SECTION 00 91 01

ADDENDUM NO. 1

BUILDINGS 5 & 6 RENOVATIONS
 San Mateo County Community College District

CAÑADA COLLEGE
 4200 Farm Hill Boulevard
 Redwood City, CA 94061

Drawing Number: **A2.3R**

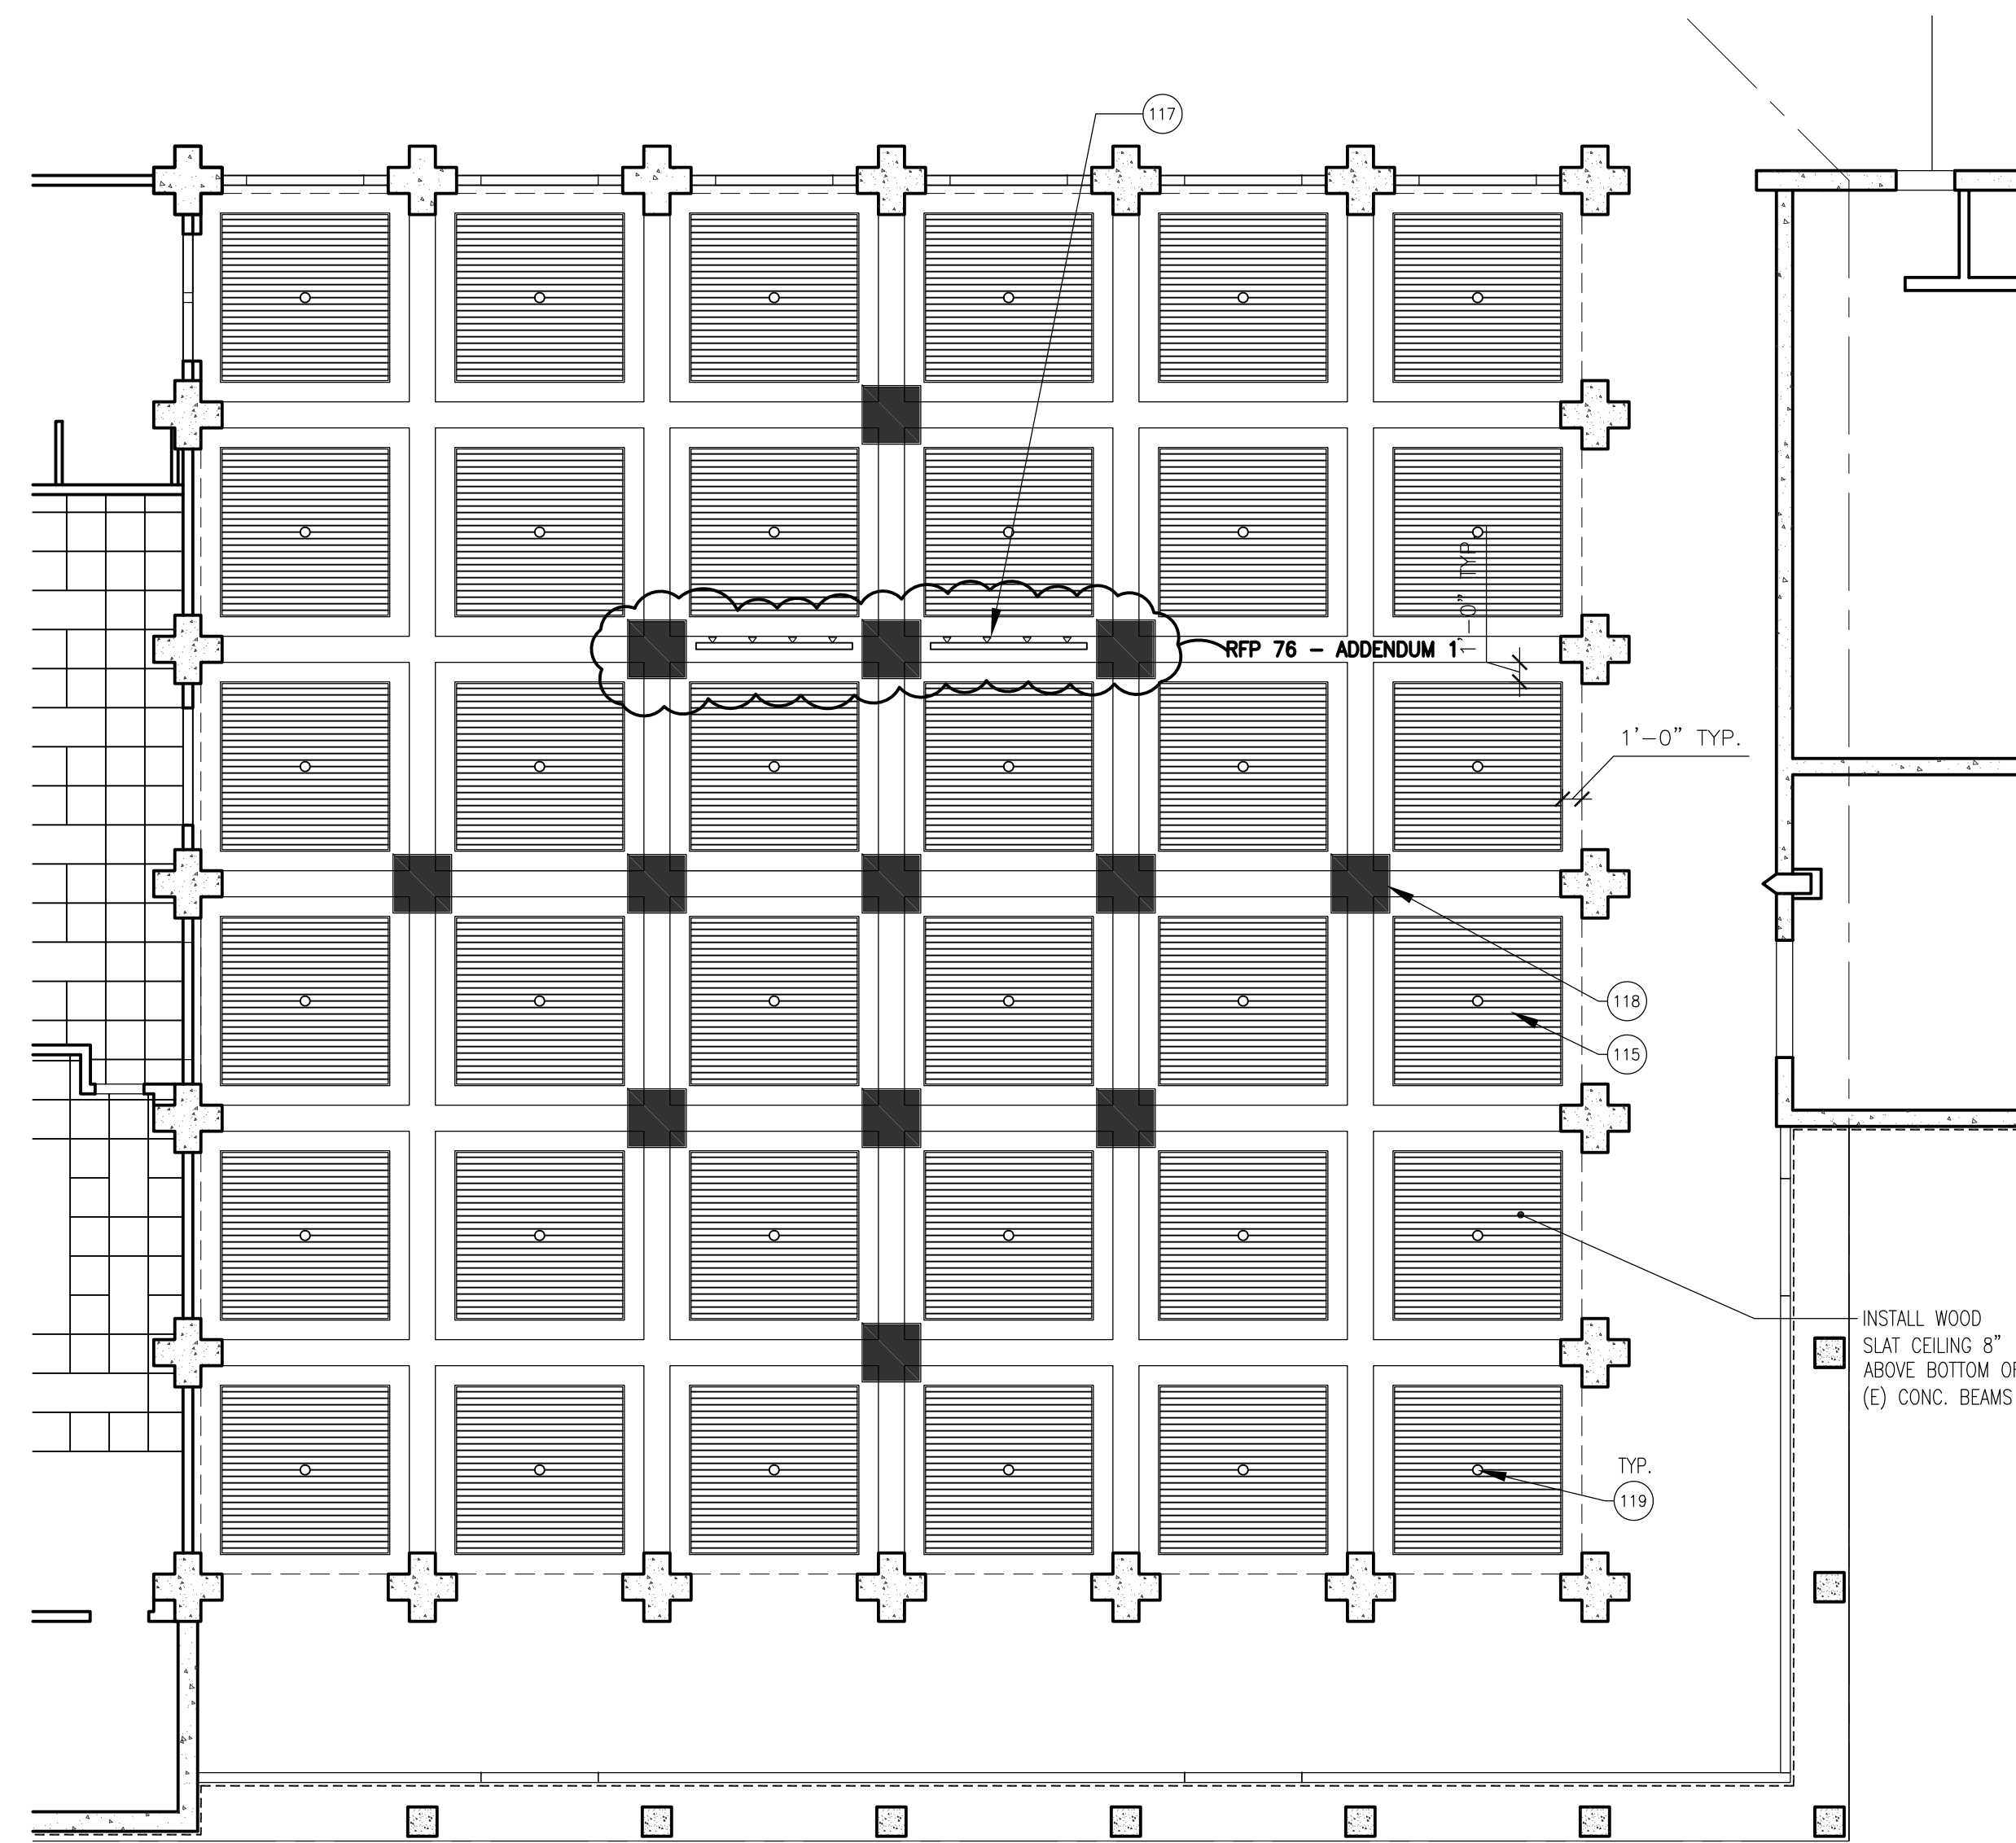
- 2. Removed Add Alternate #10 (Remote Lowering System for Stage Lighting Track) from List of Add Alternates.
- 2. Drawing A2.3R – Third Floor Plan.
 - A. Modified drawing as shown on attached revised Drawing A2.3R:

- 1. Detail 2: Removed stage lighting remote lowering system motors at Mechanical / AV & Lighting Rm 5-321.
 - 2. Detail 2: Revised Partial Floor Plan at Mechanical / AV & Lighting Rm 5-321 to show O.F.C.I. AV Equipment Rack.

Date: 04/22/11
Scale: AS NOTED
Project Number: 07013
Drawing Number: A3.34R

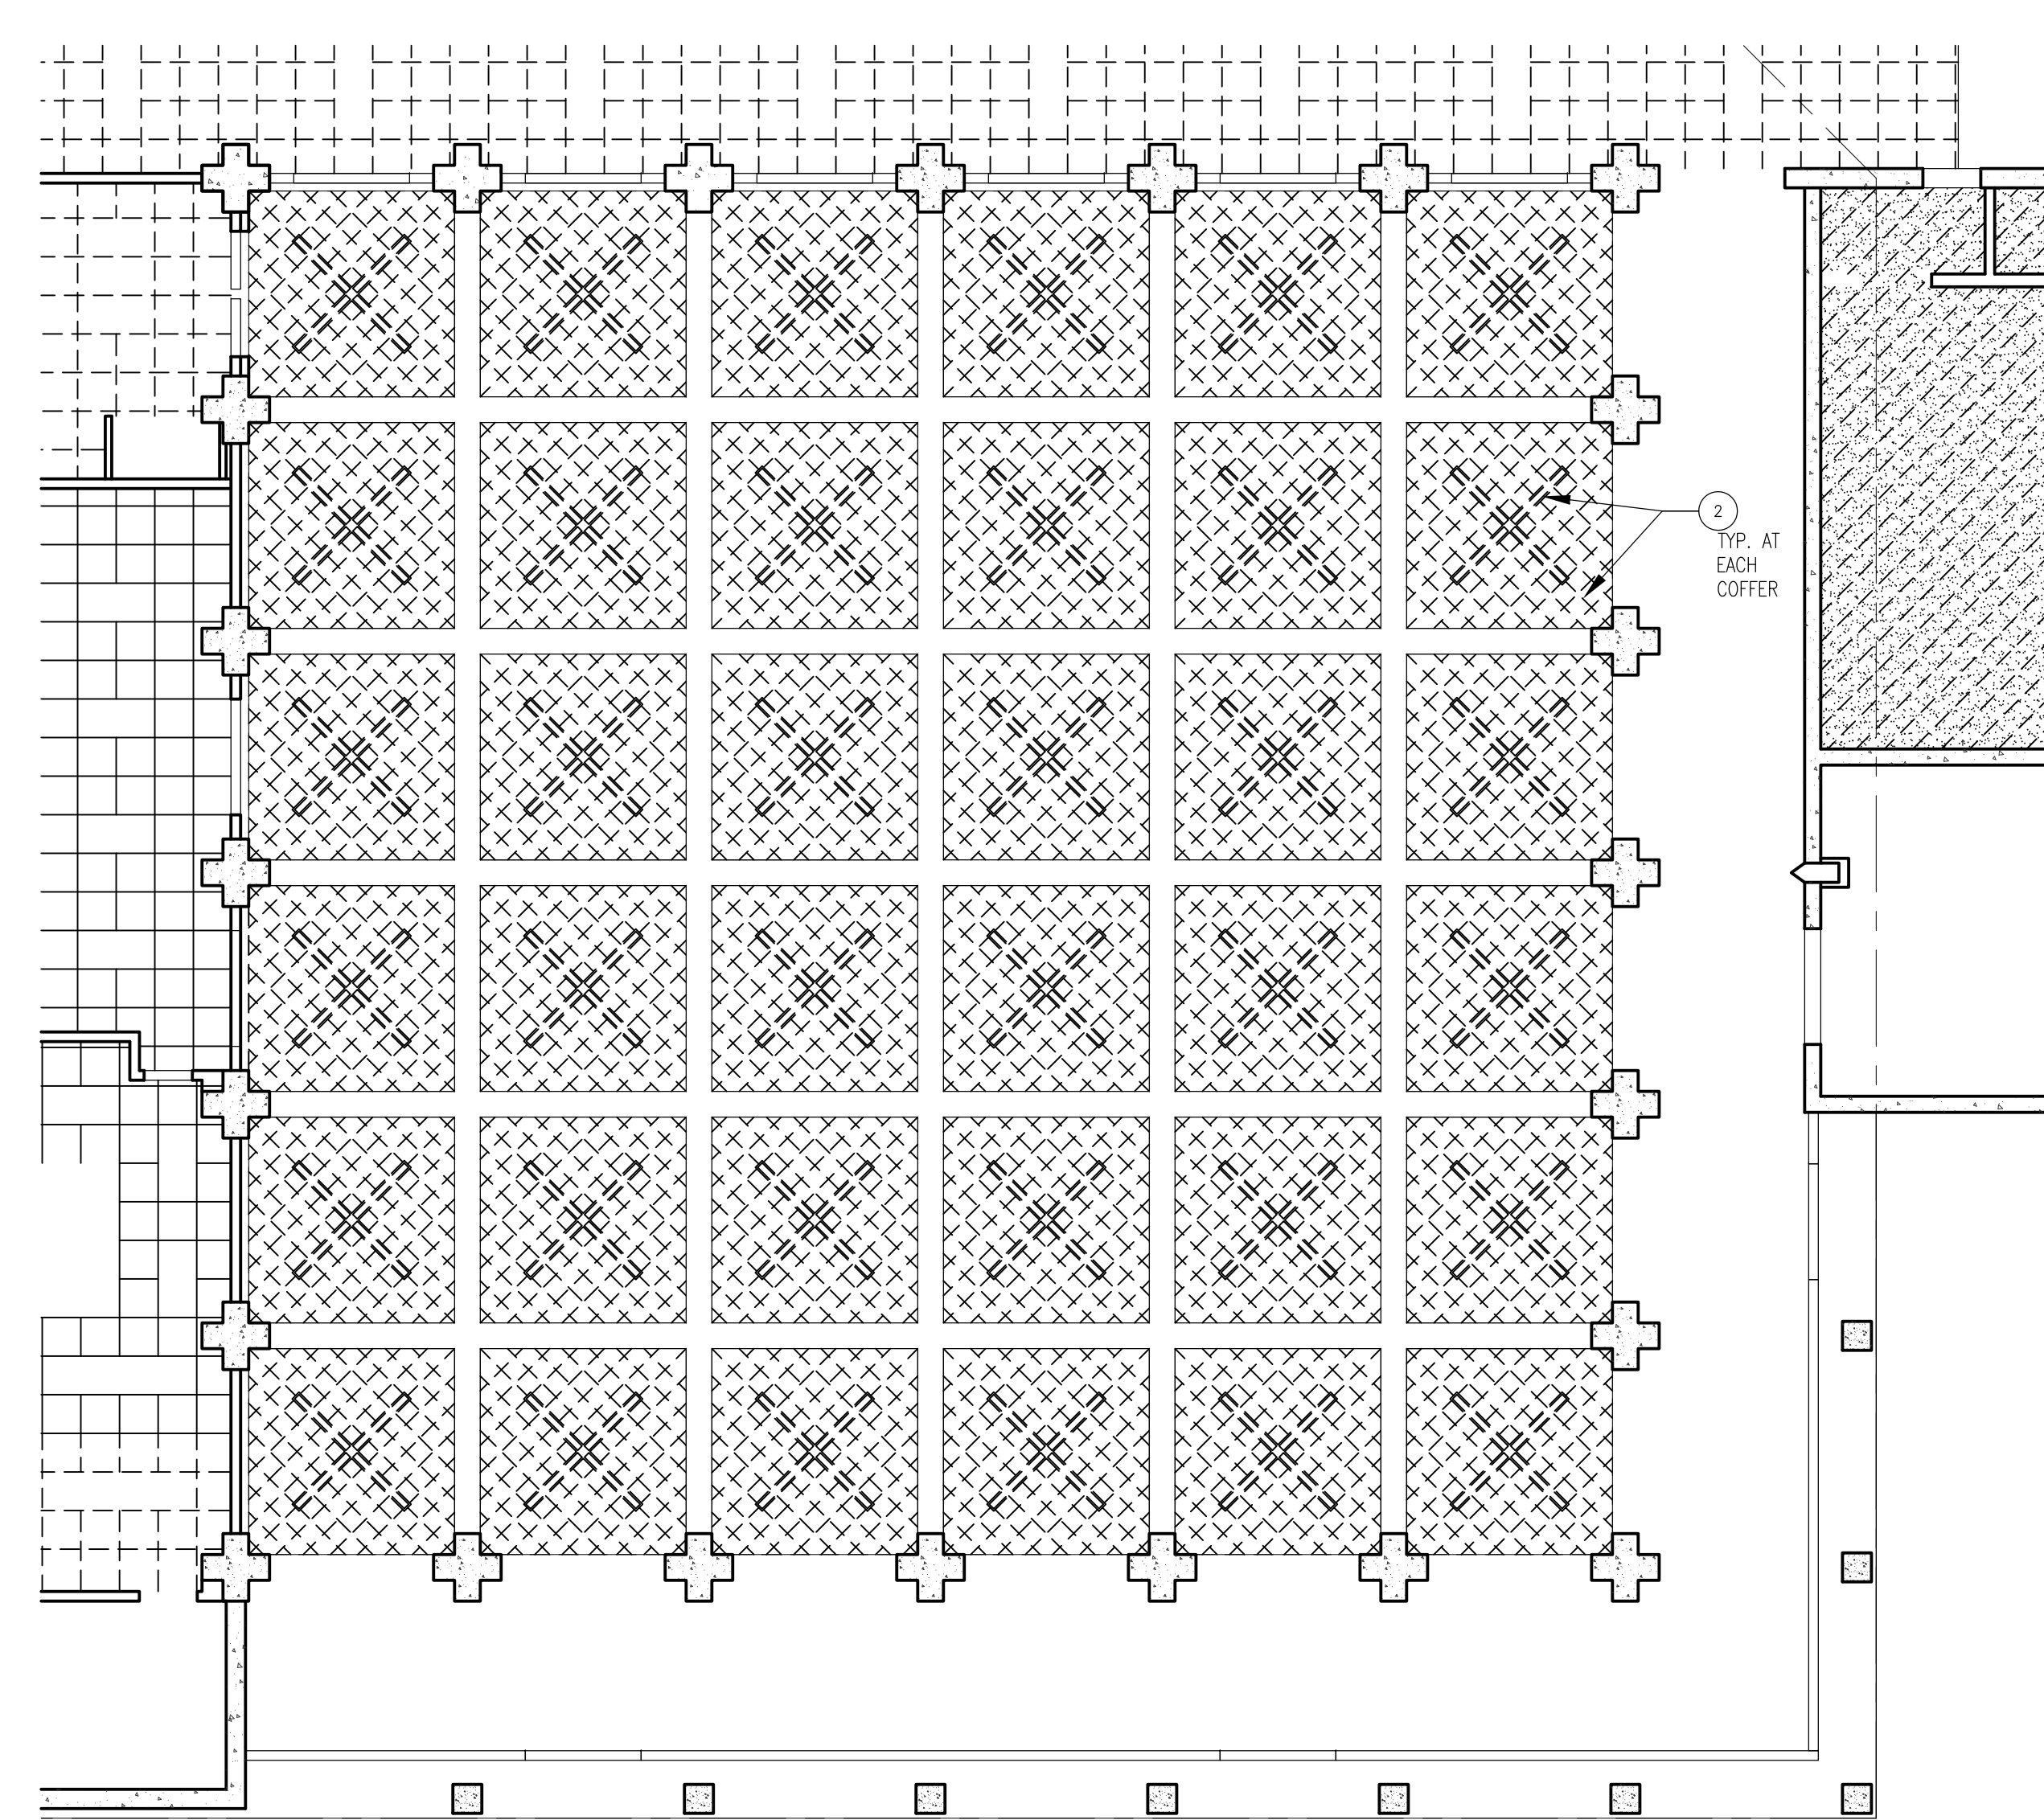
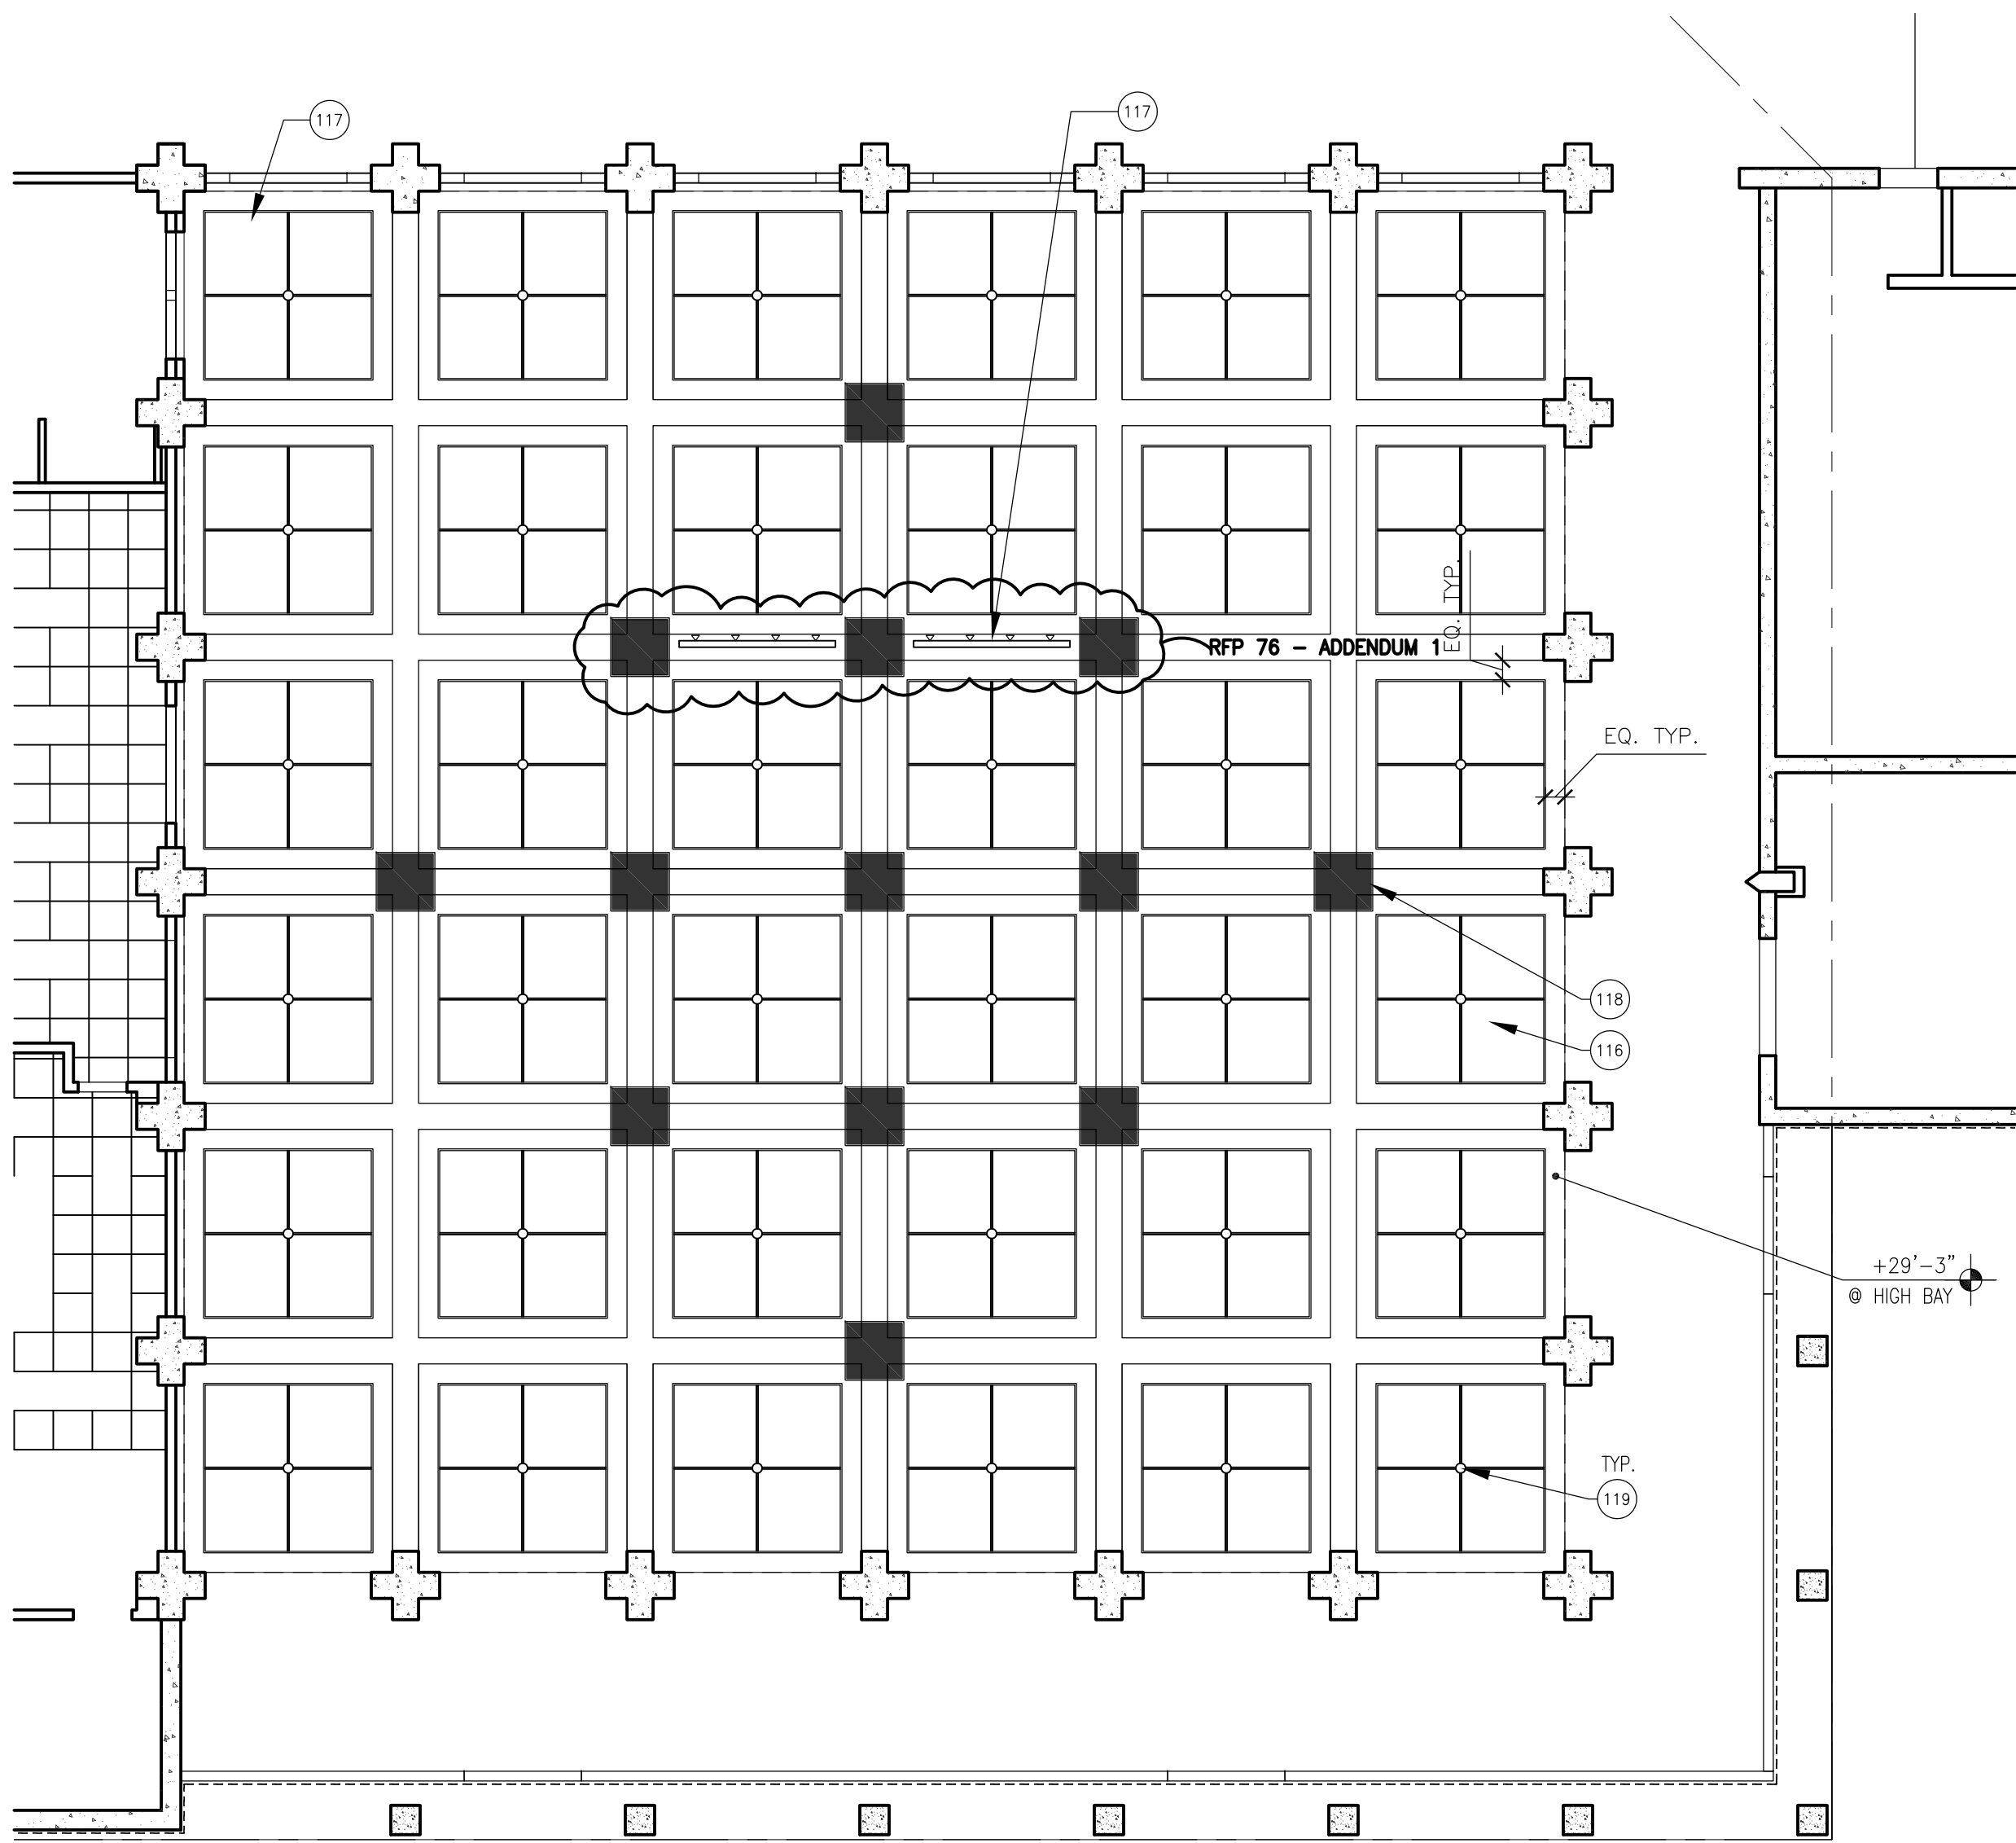
- 3. Drawing A3.34R – Third Floor Upper Reflected Ceiling Plan – Add Alternates.
 - A. Modified drawing as shown on attached revised Drawing A3.34R:
 - 1. Removed Add Alternate #10 from list of Add Alternates.

- 2. Replaced Stage Lighting Remote Lowering System with Fixed Stage Track Lighting for Detail 2, 3 and 4.
 - 3. Added Sheet Note 117 for Stage Lighting at bottom (e) coffered ceiling beam.
